DART SERVICE INSTRUCTION

TO AMEND INSTALLATION INSTRUCTIONS IIN-D117-762 REV. E AND
INSTRUCTIONS FOR CONTINUED AIRWORTHINESS ICA-D117-762 REV. 4

REF FAA STC: SR01853SE

A	NEW ISSUE	RF	17.01.09
REV.	DESCRIPTION	BY	DATE
DESIGN	RF	DART AEROSPACE, LTD EUGENE, OR	
DRAWN	RF		
CHECKED	WK	DRAWING NO.	REV.A
MFG. APPR.	N/A	DSI 9771	SHEET 1 OF 2
APPROVED	HS	TITLE	SCALE
DE APPR.	#	GHL UPGRADE KIT	NTS
DATE	17.01.09	COPYRIGHT ©2017 BY DART AEROSPACE USA, INC THIS DOCUMENT IS PRIVATE AND CONFIDENTIAL AND IS SUPPLIED ON THE EXPRESS CONDITION THAT IT IS NOT TO BE USED FOR ANY PURPOSE OR COPIED OR COMMUNICATED TO ANY OTHER PERSON WITHOUT WRITTEN PERMISSION FROM DART AEROSPACE, LTD.

FIGURE 1 - GHU UPGRADE INSTALLATION

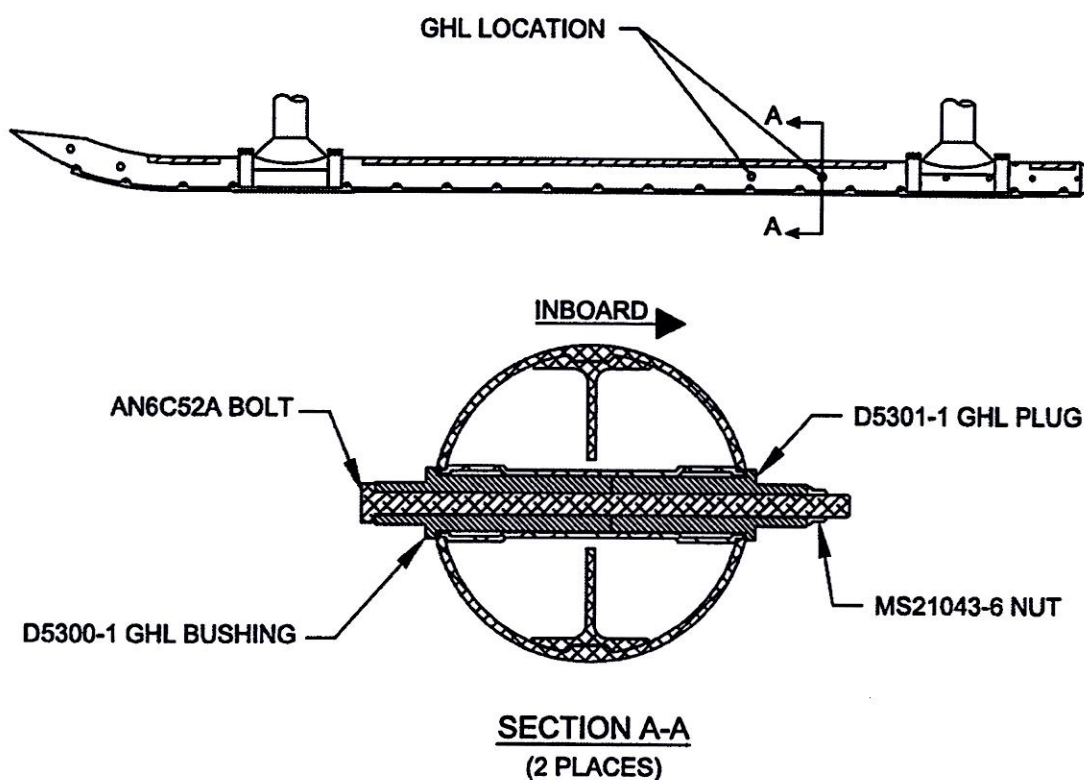
The purpose of this Dart Service Instruction (DSI) is to replace the ground handling lugs (D3864-1 Bushings, AN6C51A Bolts and MS21043-6 Nuts) on the D117-762-XXX Skidtubes with a structurally superior lug design (D5300-1 Bushings, D5301-1 Plugs, AN6C52A Bolts, MS21043-6 Nuts) as shown in Figure 1. The new hardware will be included in D117-762-011 @ CHG 004 and subsequent.

- 2.1 Loosely install (qty 2) D5300-1 GHL Bushing & (qty 2) D5301-1 GHL Plug wet with Proseal 890 or MIL-S-8802 Class B2 Sealant in location shown in Figure 1.
- 2.2 Install (qty 2) AN6C52A Bolts and (qty 2) MS21043-6 Nuts in accordance with Figure 1. Clean up squeezed out Proseal and apply fillet seal around D5300-1 & D5301-1.
- 2.3 Torque AN6C52A Bolts 160 - 190 in-lbs (18.1 - 21.5 N-m).

ITEM	QTY -011	PART NUMBER	DESCRIPTION
	X	D117-762-011	SKIDTUBE INSTALLATION
50	2	AN6C52A	BOLT
51A	2	D5300-1	GHL BUSHING
51B	2	D5301-1	GHL PLUG
52	2	MS21043-6	NUT

ITEM	QTY -011	PART NUMBER	DESCRIPTION
	X	D117-762-011	SKIDTUBE INSTALLATION
50	2	AN6C51A	BOLT
51	4	D3864-1	BUSHING
52	2	MS21043-6	NUT
